Addendum No. 1

Project Name: N5012(1)1,2&4 Road Improvement Project in Sanostee, NM

Owner: Navajo Division of Transportation

4. Sheets 2, 3, 5, 8, 11, 17, 18, 19, 38, 39, 40, 61A, 61B, 65 and 66 of the N5012(1) plans have been revised. Revisions included changing the class of riprap from "Class 2" to "Class 1" and adding in the subgrade stabilization notes from the Pre-Proposal Meeting Agenda.

REGION	STATE	RESERVATION	ROUTE	PROJECT NO.	SHEET	TOTAL SHEETS
NORTH	NEW MEXICO	NAVAJO	N5012	N5012(1)1,2&4	8	75

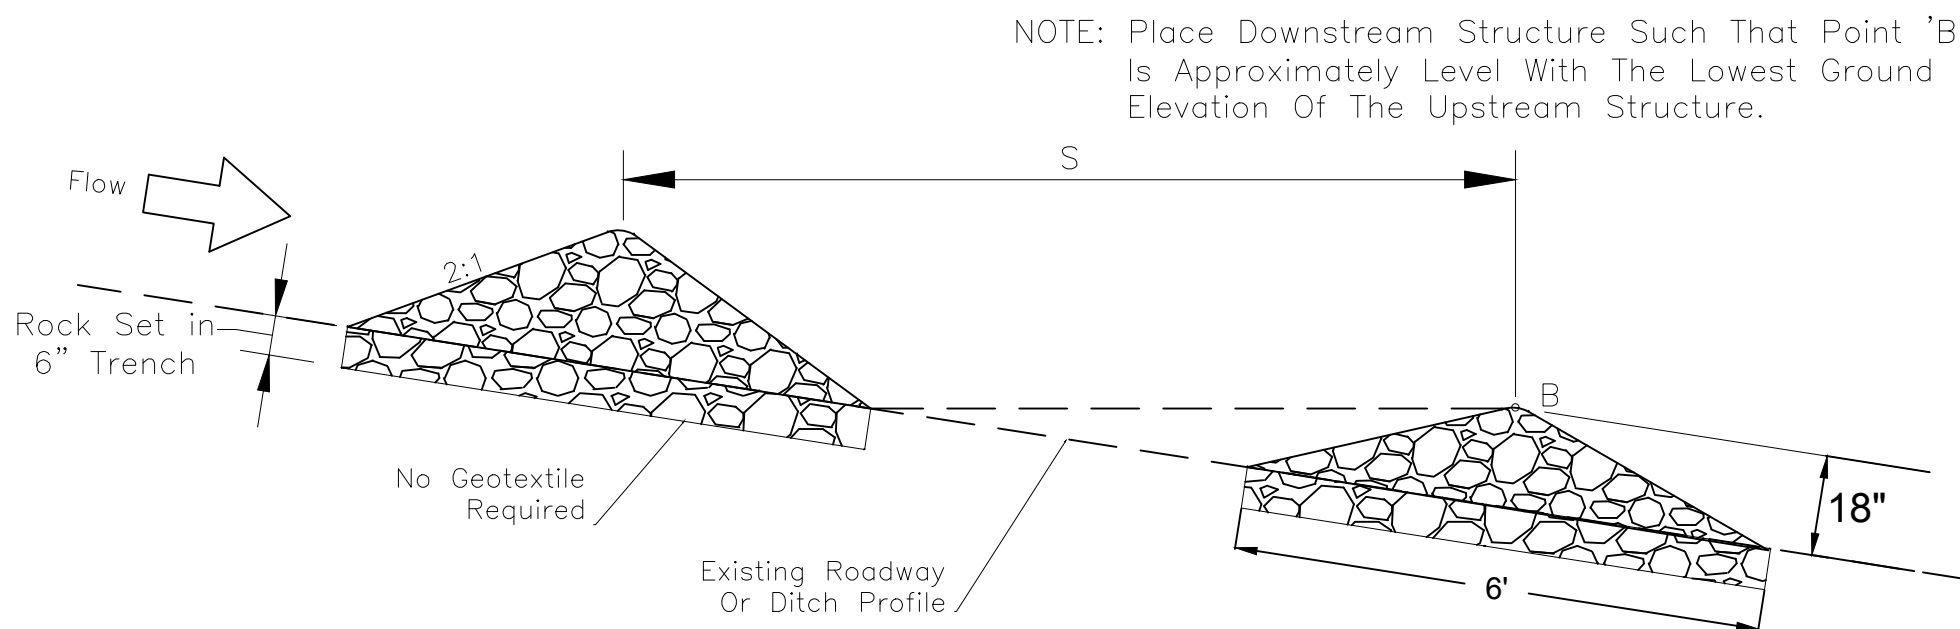
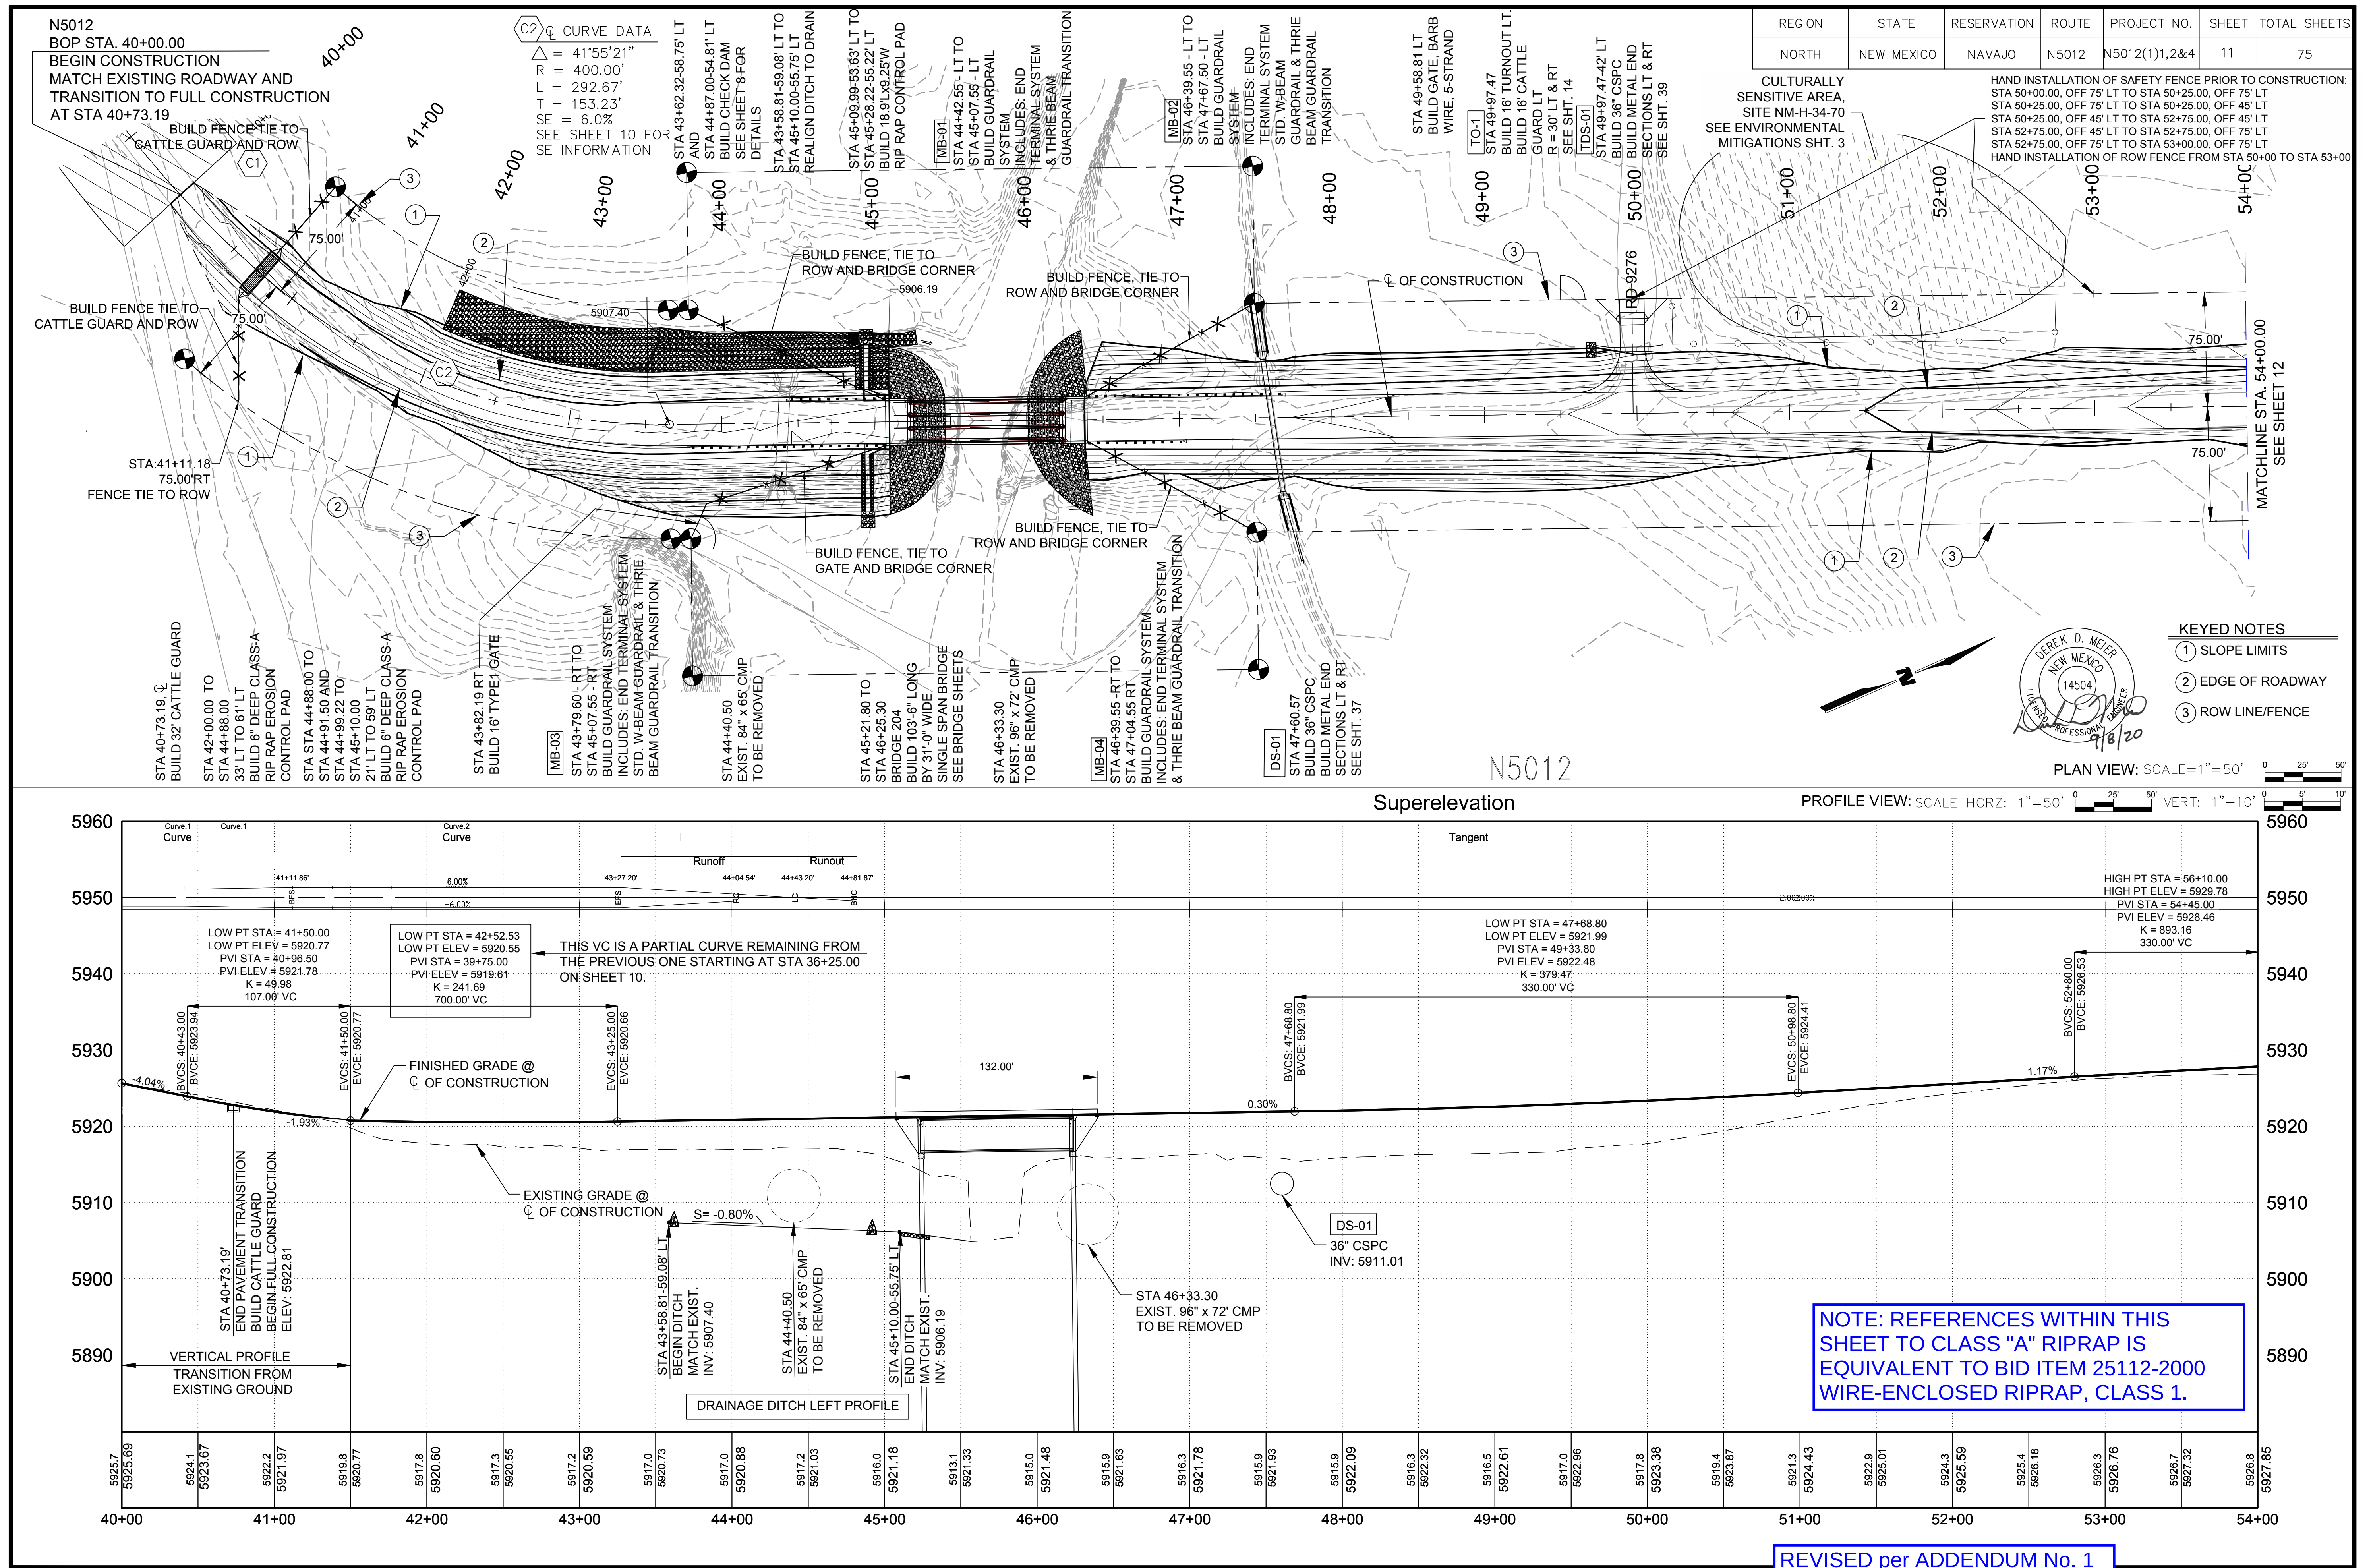
- All Stone For Placed Riprap To Be Class 1 Meeting The Grading Requirements Of Table 705-1, And Section 251 Of The FP-14.

REVISED per ADDENDUM No. 1

REGION	STATE	RESERVATION	ROUTE	PROJECT NO.	SHEET	TOTAL SHEETS
NORTH	NEW MEXICO	NAVAJO	N5012	N5012(1)1,2&4	17	75

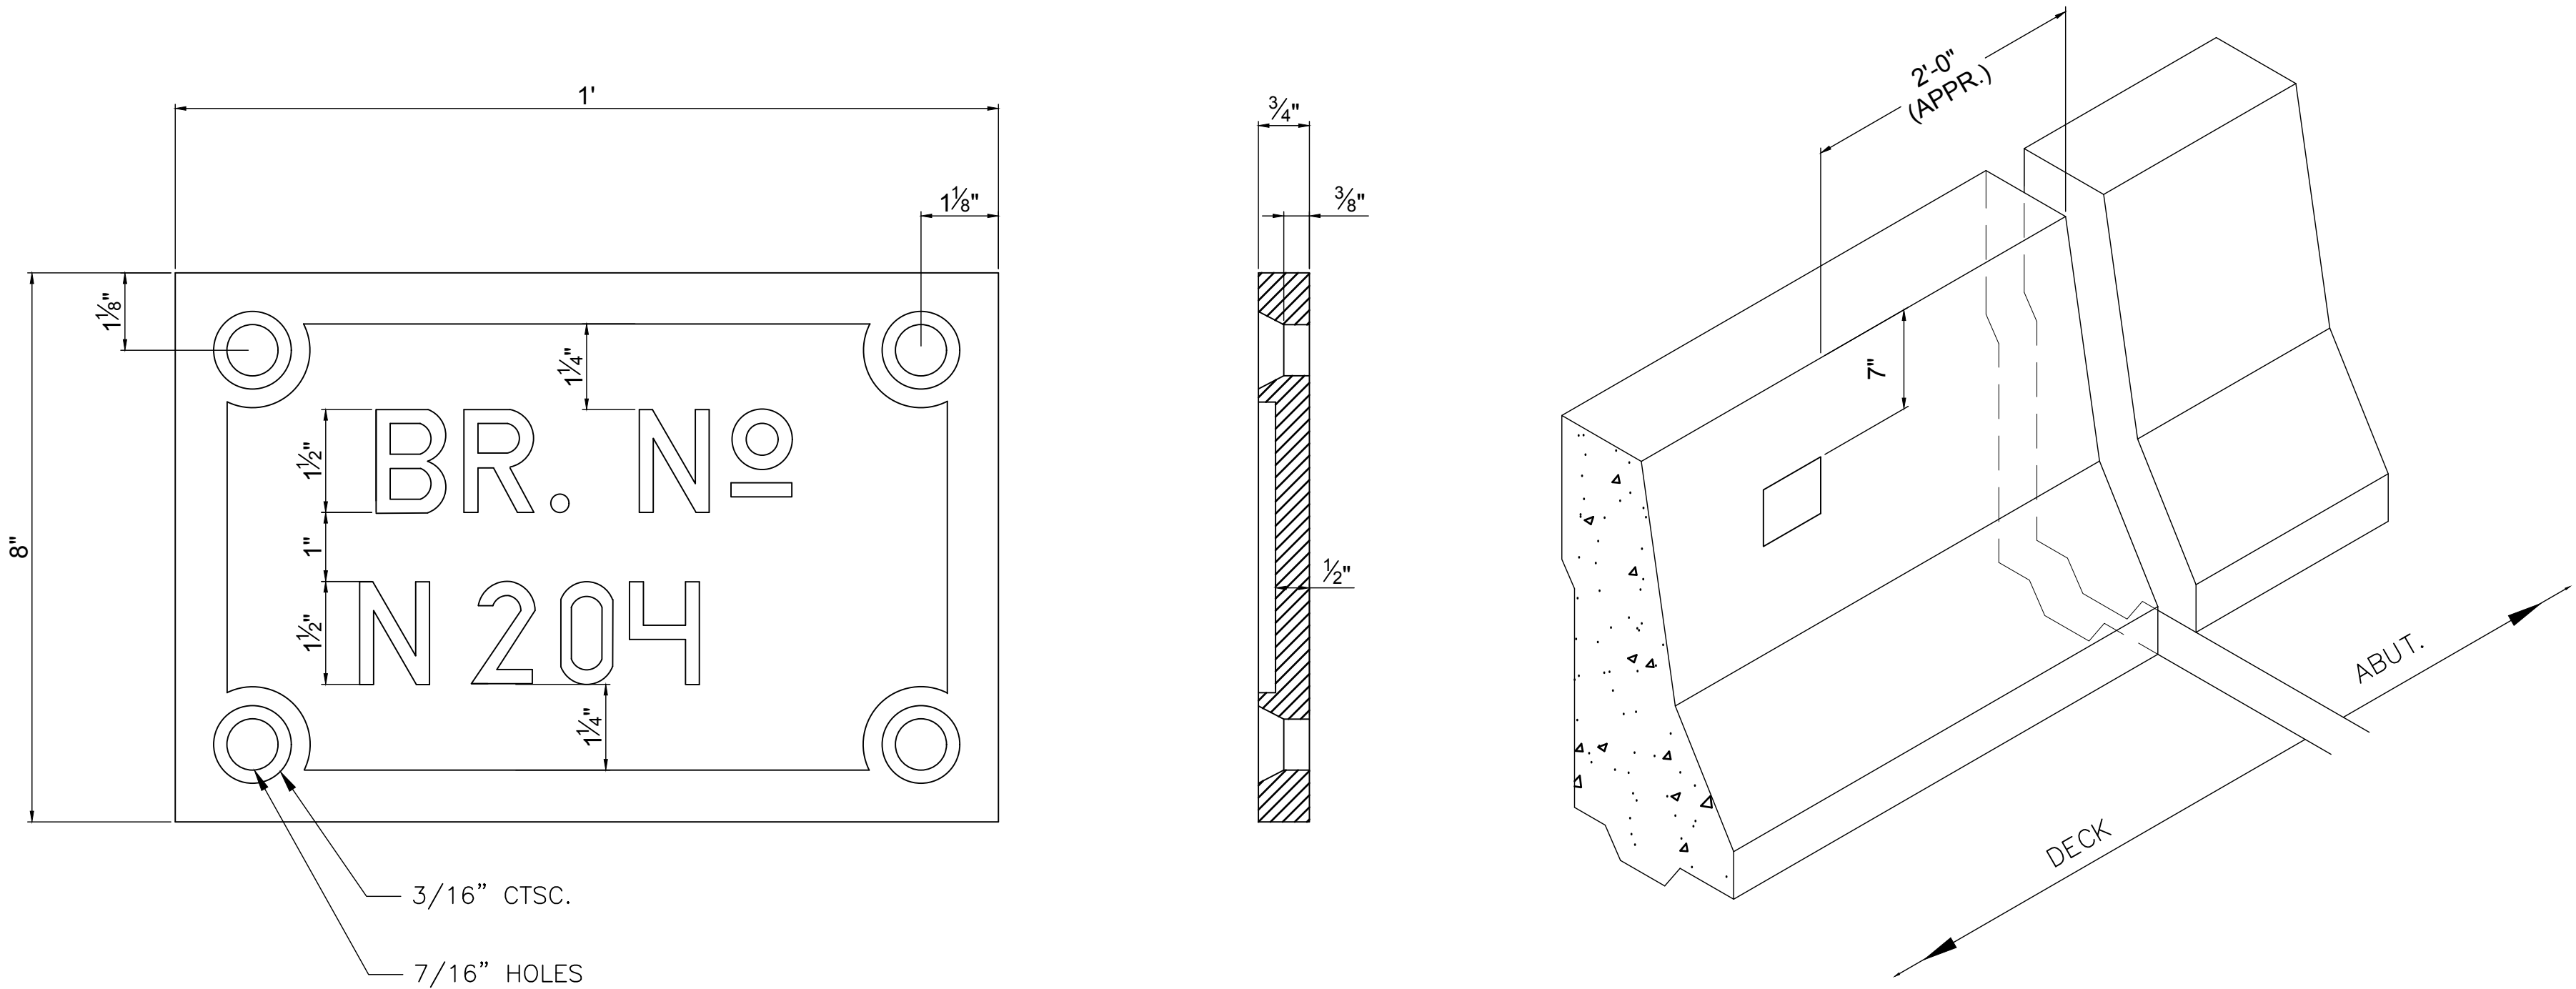
ESTIMATED QUANTITIES								
ITEM NO.	ITEM DESCRIPTION	UNIT	SUPER STRUCTURE	SUBSTRUCTURE		APPR. SLABS	EMBANKMENT PROTECTION (RUNDOWNS)	TOTAL QUANTITY
				ABUTMENT	ABUTMENT			
				NO.1	NO.2			
20801-0000	STRUCTURE EXCAVATION	CU.YD.		134	154			288
20803-0000	STRUCTURAL BACKFILL	CU.YD.		295	301			596
25101-0100	PLACED RIPRAP, METHOD A, CLASS 1	CU.YD.					37	37
25112-2000	WIRE ENCLOSED RIPRAP, CLASS 1	CU.YD.		159	167		7	333
55201-0100	STRUCTURAL CONCRETE, CLASS A	CU.YD.		17	17			34
55201-0200	STRUCTURAL CONCRETE, CLASS A (AE)	CU.YD.	161			45		206
55302-3300	PRECAST, PRESTRESSED CONCRETE AASHTO GIRDER	LIN.FT.	402					402
55401-1000	REINFORCING STEEL	LBS.		13695	12810			26505
55401-2000	REINFORCING STEEL, EPOXY COATED	LBS.	21280			8580		29860
55502-0000	STRUCTURAL STEEL, FURNISHED, FABRICATED, AND ERECTED	LBS.	2530					2530
55601-0500	BRIDGE RAILING, CONCRETE 42"	LIN.FT.	264					264
55901-0000	MEMBRANE WATERPROOFING	SQ.YD.	396					396

REVISED per ADDENDUM No. 1
